SUPPLEMENTARY REPORT:

230 Victoria Rd Gladesville. Lot 3 DP 527517 Local Development Application for demolition of existing commercial building and construction of a seven storey mixed use development comprising of 2 x commercial tenancies on the ground level, 88 residential units comprising of 30 x 1 bedroom, 53 x 2 bedroom, 5 x 3 bedrooms and one and a half level of basement parking for 113 vehicles. JRPP No. 2015SYE118. LDA2015/0433.

Figure 1: Section illustrating the maximum building height allowed across the site and the lift overrun non-compliance in Building A.

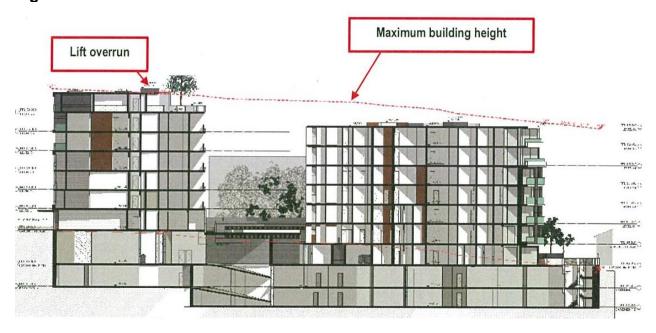
The development complies with the height control except for the lift overrun for Building A. The lift overrun will have an overall height of 23m which is 1m over the maximum allowed which is a 4.5% variation. This breach in height is for Building A lift overrun only. The area of non compliance to the height control is demonstrated in **Figure 1** below.

Agreed with the above – the exceedance is negligible within the streetscape and urban context generally and the lift overrun will not be seen from Victoria Road. The exceedance will have negligible impact to adjoining neighbours in terms of overshadowing, overlooking or visual impact. Accordingly the proposal meets the objectives of the development standard. In addition, the proposal meets the objectives of the B4 zone by providing a mixture of compatible land uses in an accessible location close to public transport. The variation is due to lift access which provides appropriate residential amenity for the residents. There are sufficient environmental planning grounds to justify contravening the development standard.

The variation to the height standard is supported.
